Subject: **ACTIVE TRANSPORTATION PROGRAM – PROJECT SCOPE AMENDMENT–
SANTA FE DRIVE CORRIDOR BIKE AND PEDESTRIAN IMPROVEMENTS
PROJECT
RESOLUTION ATP-P-2526-14**

Exhibit 25-D Request for
Project Scope Change

SANTA FE DRIVE CORRIDOR PEDESTRIAN & BIKE IMPROVEMENTS
ATTACHMENT D- EXISTING CONDITIONS

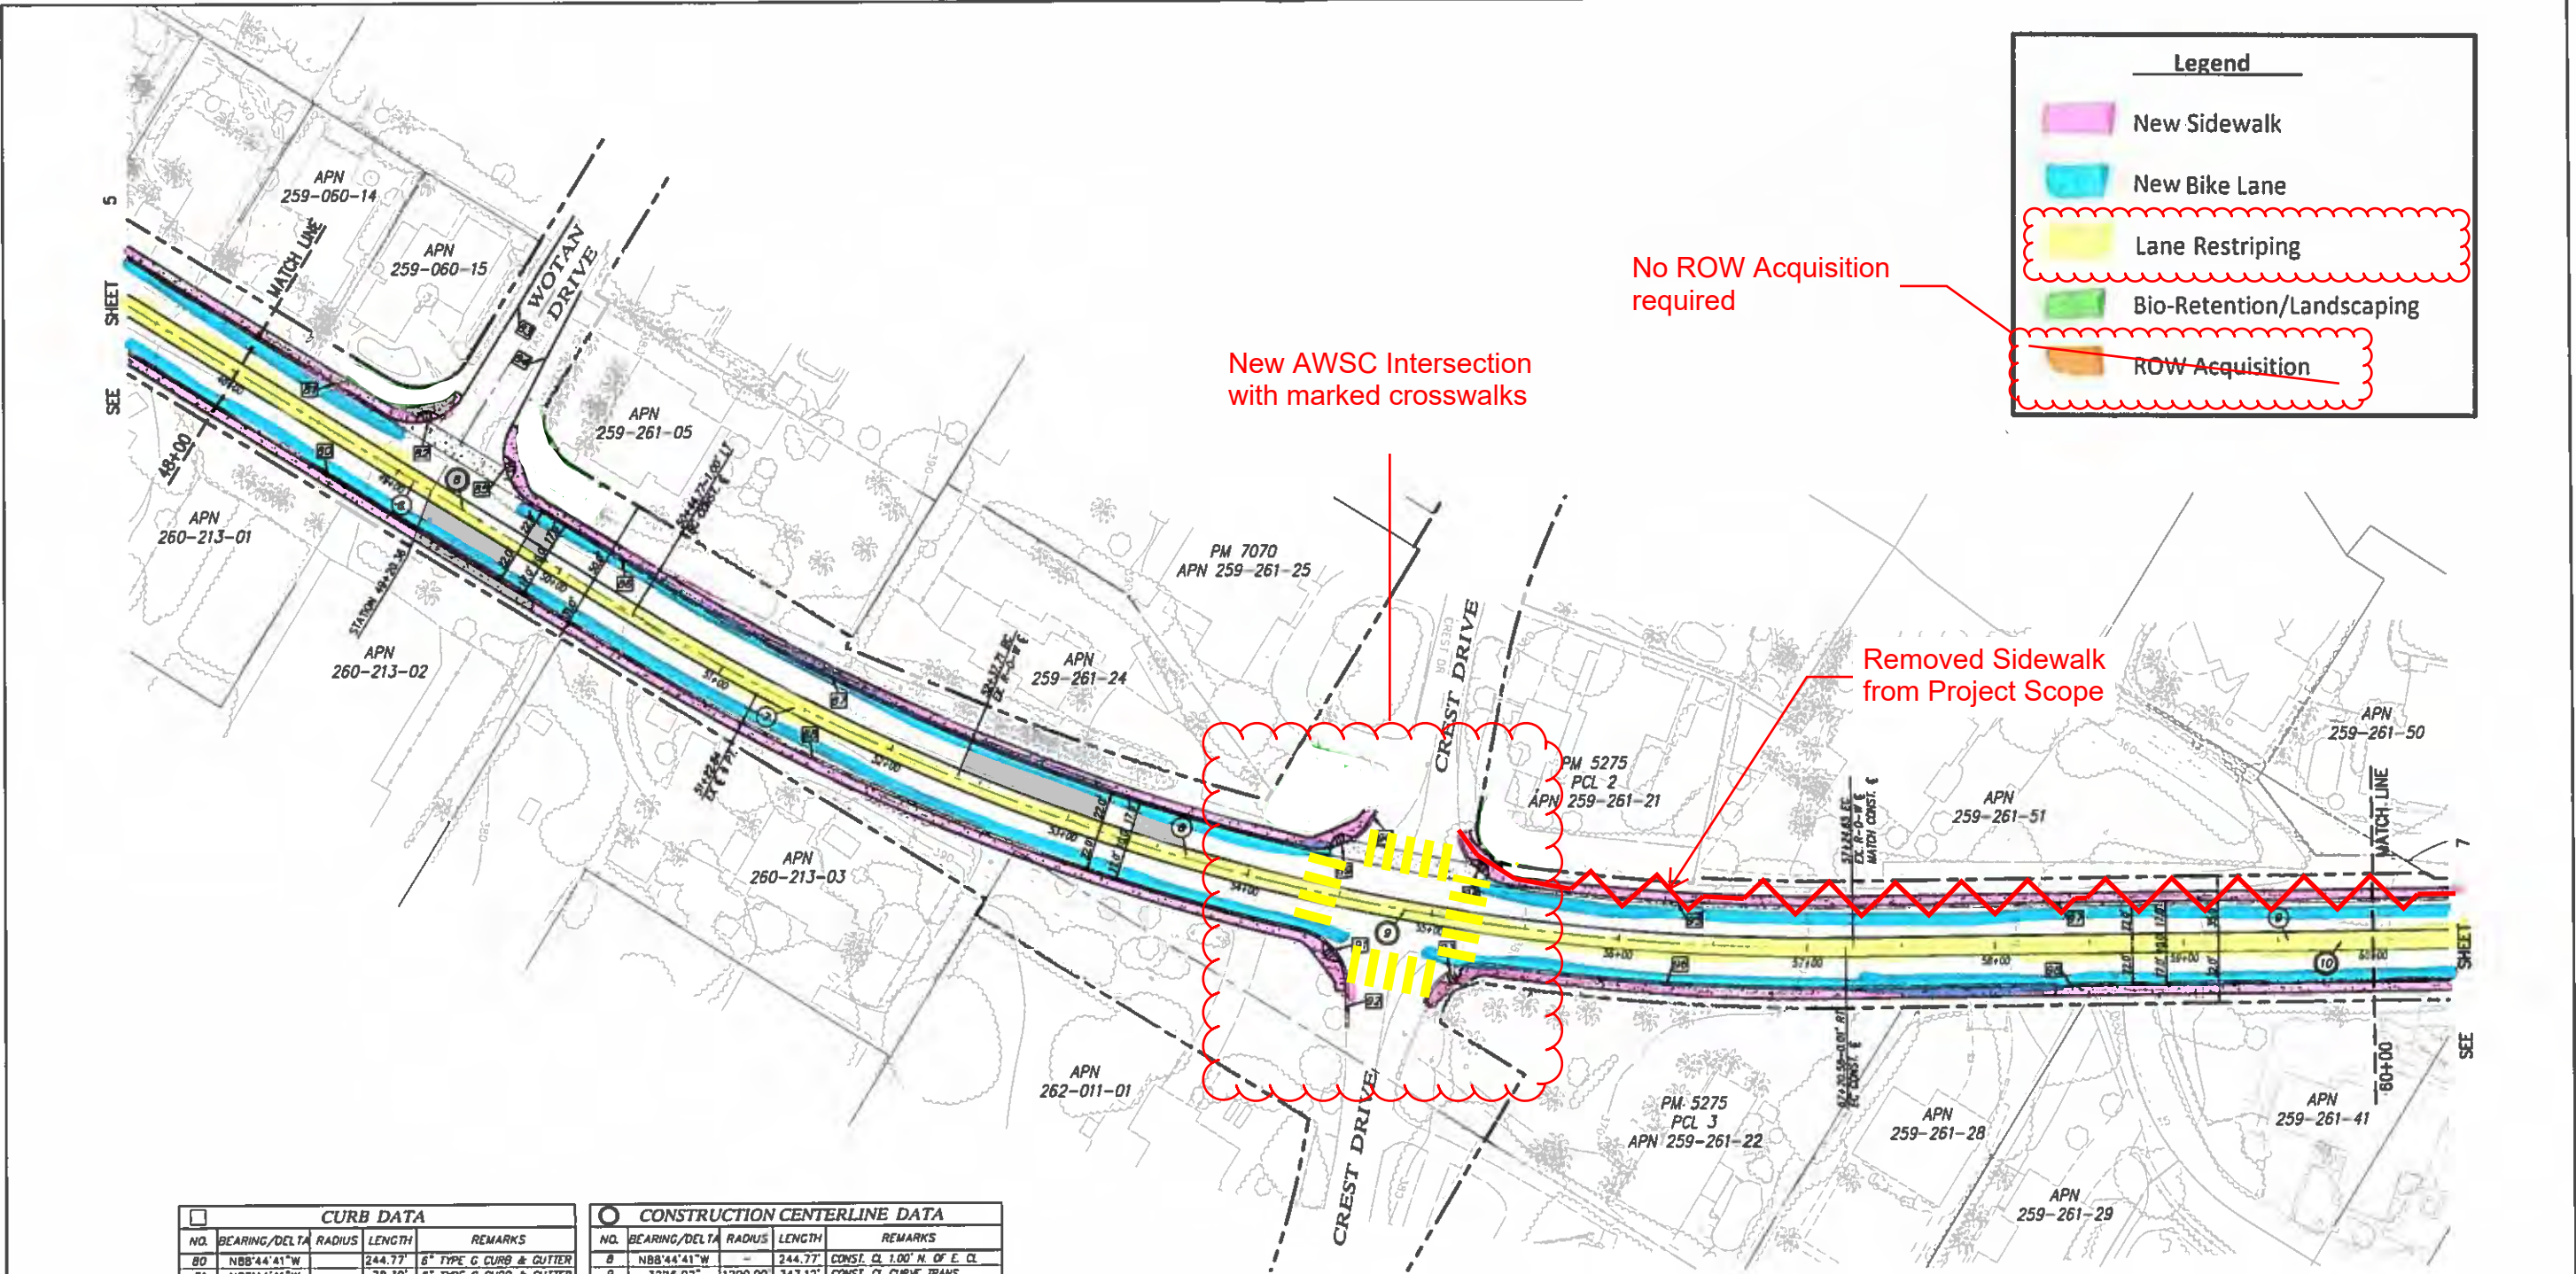
New AWSC Intersection with marked crosswalks

Removed Sidewalk from Project Scope

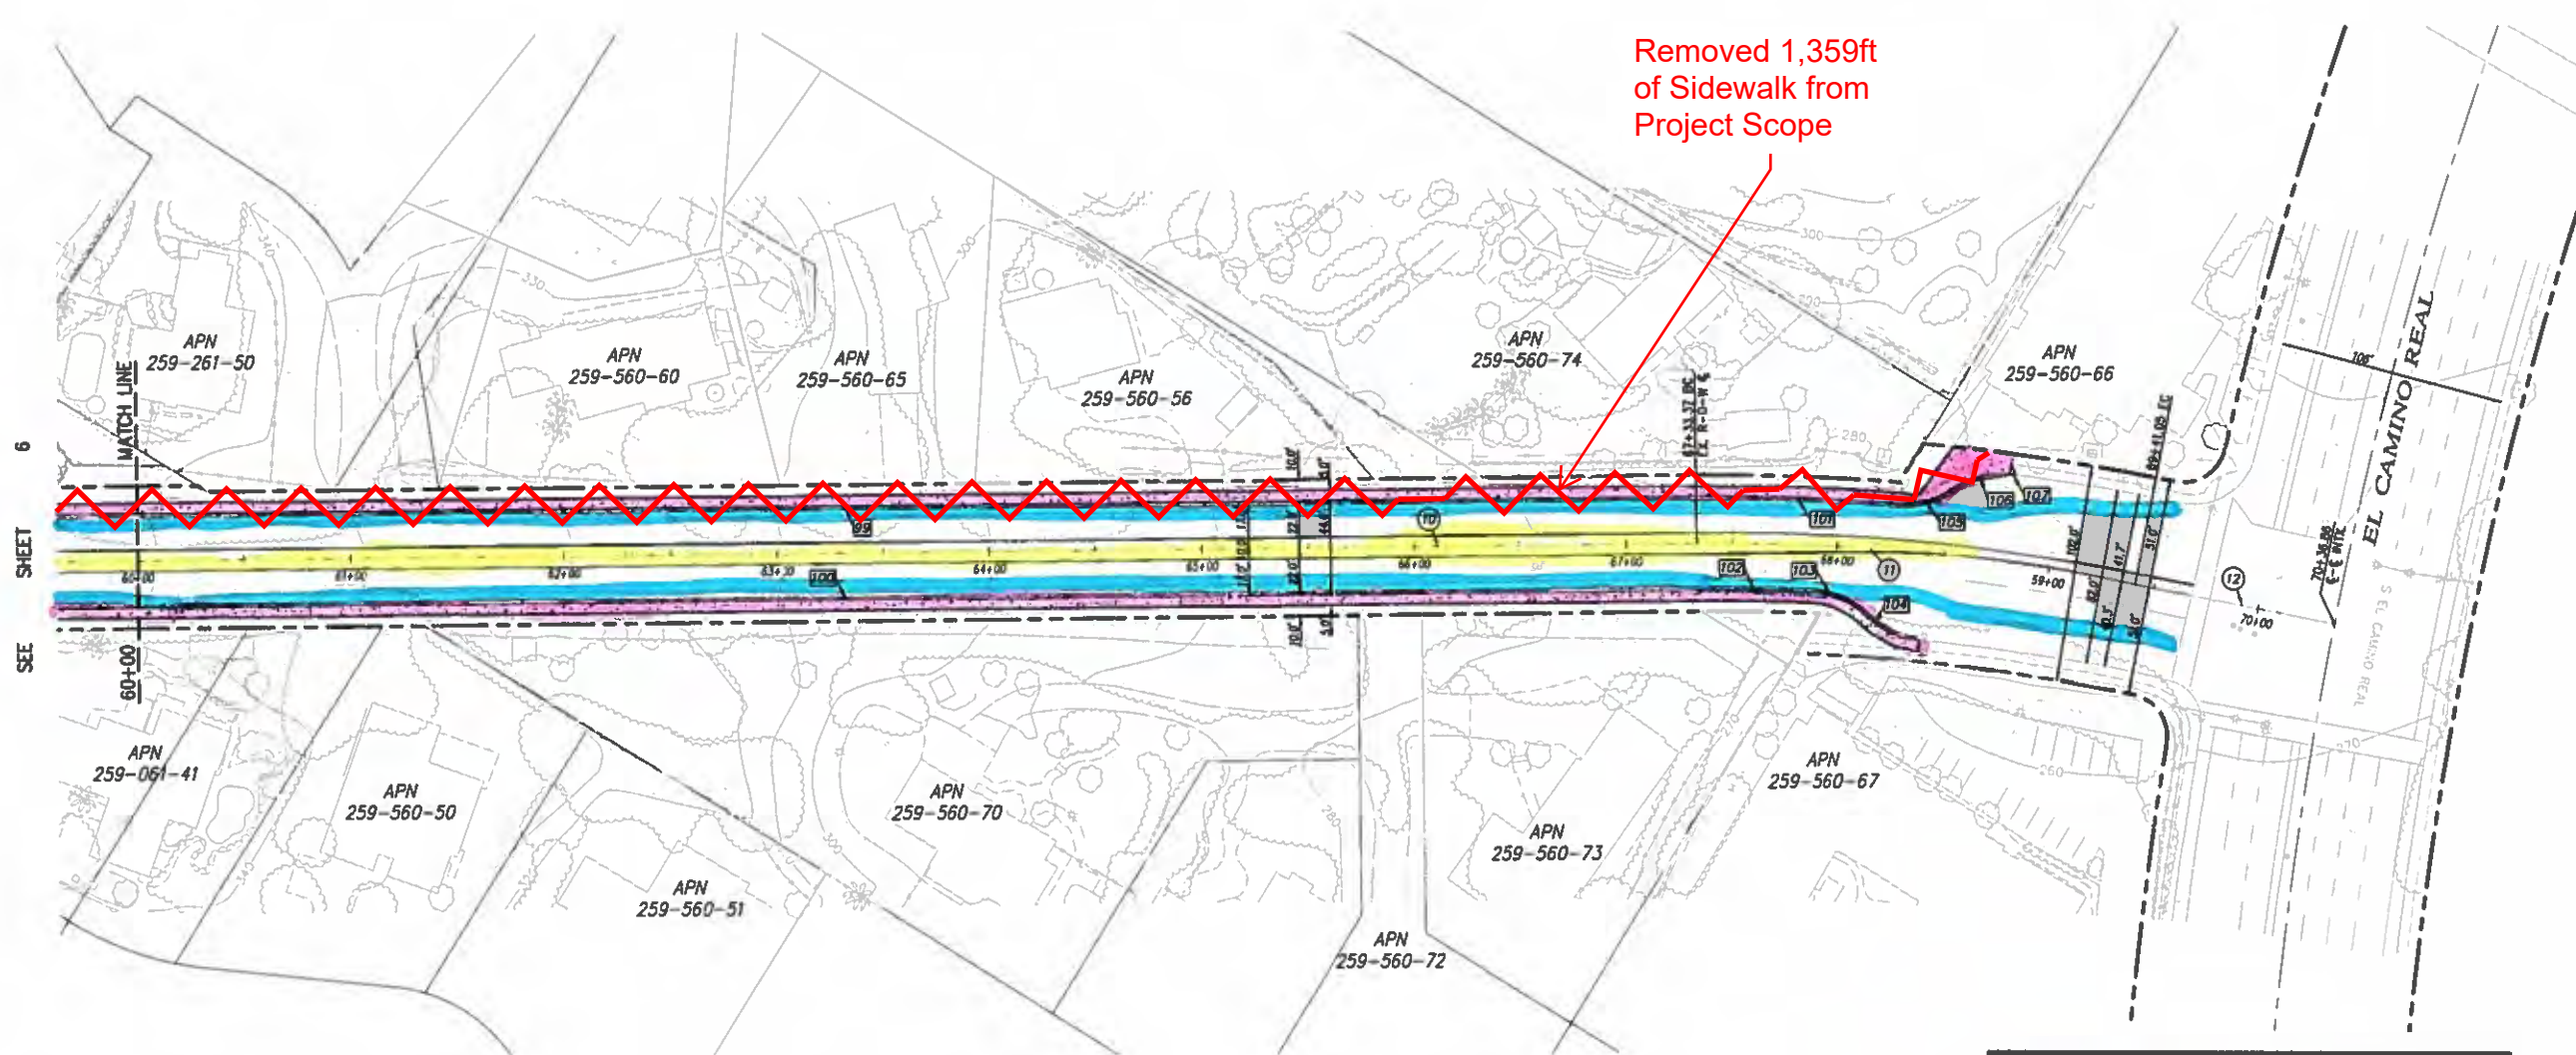
Removed 1,359ft
of Sidewalk from
Project Scope
